U.S. Department  
of Transportation  
**Federal Highway  
Administration**

Refer to: HNG-14

On March 31 you met with representatives of my office and other Federal Highway Administration (FHWA) offices to present information on your BarrierGate system and to request FHWA acceptance of this device for use on Federal-aid highway projects.

The BarrierGate is a longitudinal barrier used in conjunction with a concrete safety shape to provide a temporary opening in the continuous barrier for use by emergency vehicles or re-routed traffic. The BarrierGate consists of two half gates made with three-beam rail elements. These half gates slide along a track system and are opened by an electrical winch. A manual override system can be used in the event a power failure occurs. Separate fixed concrete safety shape end sections, and intermediate, shorter CMB sections complete the system. The enclosure details each of these elements.

**BARRIER GATE SYSTEM  
SITE LAYOUT**

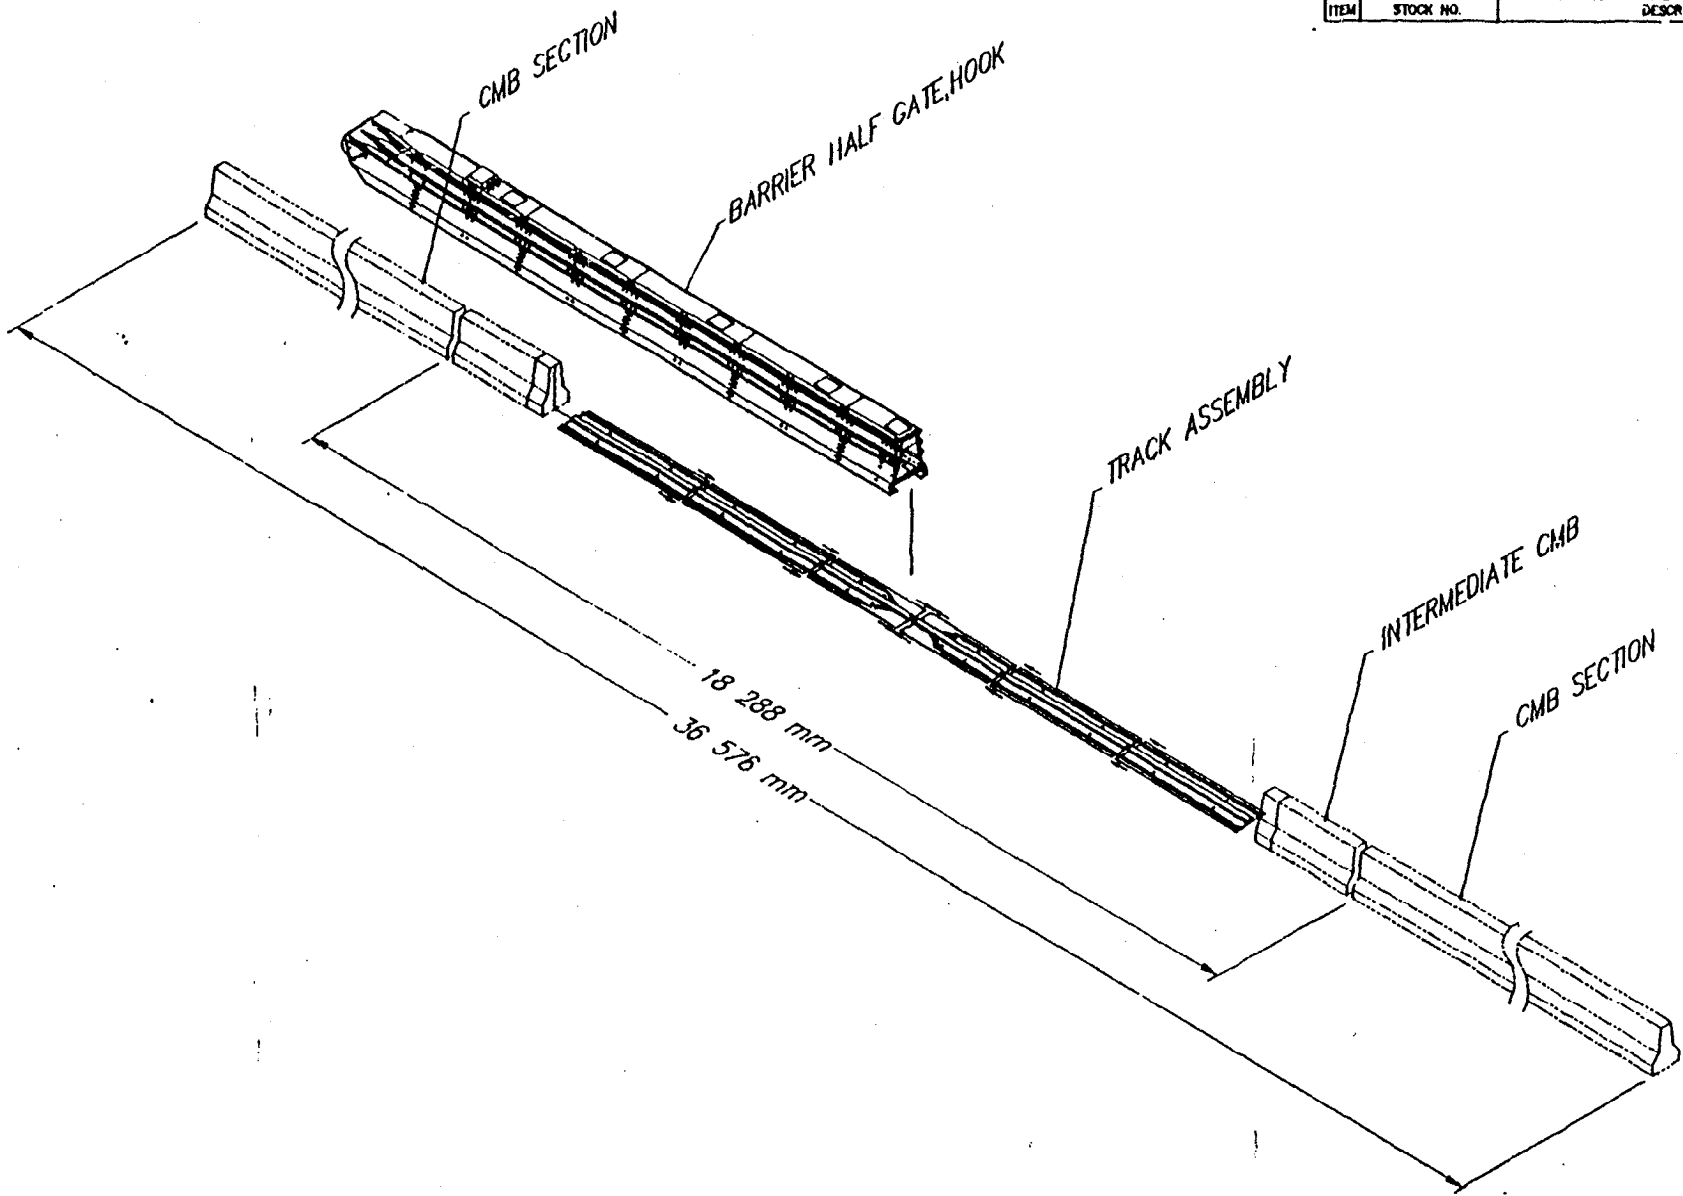
While reviewing the draft test report we noted some areas in need of clarification or correction. Specifically, Table 4 on page 29 indicates that the test vehicles stopped "in contact with the barrier." Clearly this was not so; each of the test vehicles was stopped after leaving the BarrierGate by impacting Triton units. Due to the placement of the latter, it is not certain how far into adjacent lanes any of the test vehicles would have traveled.

The impact severity (IS) of test 150-006 was very near the lower limit in the NCHRP Report 350 for test 3-11 and the impact speed was less than the minimum value of 96 km/h suggested in Table 3.5 of the report. The NCHRP Report 350 further recommends that the IS for a longitudinal barrier equal or exceed the target value.--However, since the vehicles in tests 3-11 (strength) and 3-21 (transition) both struck near the center of the barrier and the test criteria were met fully in the second test with the barrier showing significant reserve strength, we will accept the overall results. A discussion of how the critical impact point (CIP) for the transition test was selected would be useful as there is some question whether or not a point closer to the intermediate CMB section is more critical than the selected impact location.

We noted in both 25 degree tests that the dynamic deflection of the barrier was approximately one meter. It is also apparent that the BarrierGate has a lower ultimate performance limit than the concrete safety shape in which it is used. These may be a factors to consider at locations where high-speed, high-angle impacts are likely and where commercial trucks constitute a significant percentage of the traffic stream.
